Access Compliance Report Public Rights-of-Way (Curb Ramps)

Main Street: N/A Cross Street: PROSPECT_ST Location: NW

ADA ID: RPAT211028084344 Ramp Type: Type 1 - Perpendicular Diagonal Initial Pass/Fail: Fail Overall Compliance: No Severity Score: 5

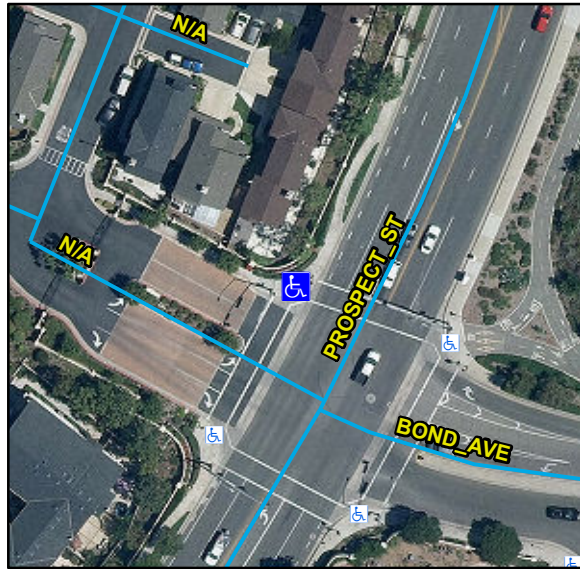
R304.2.2, R304.5.1, STD 1115

Remove & Replace Curb Ramp With Two New Directional Ramps or Equivalent.
